Inspection Report Summary

Facility: Westdale School

Machine: General International Band Saw

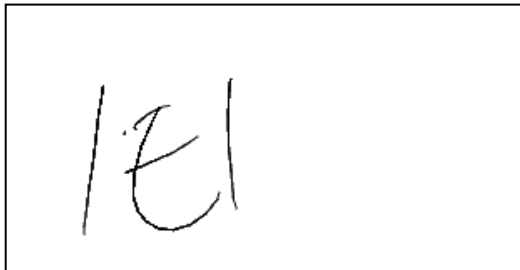
Activity/Tasks	Hazards	Corrective Action	Pass/Fail	Severity	Exposure	Avoidance	Total	Current Safeguards	Recommended Improvements
Cut part	Amputation from blade	2026 Inspection - Replace blade guard to cover exposed side of blade 	Fail	2	2	2	PR1 8	Adjustable blade guard	
Third party access	Laceration, amputation from blade		Pass	2	2	2	PR1 8	Blade guard, located against wall, hazard markings on floor	
Operate machine	Crush, entangle in power transmission		Pass	2	2	2	PR1 8	Hinged guards - secured with bolts
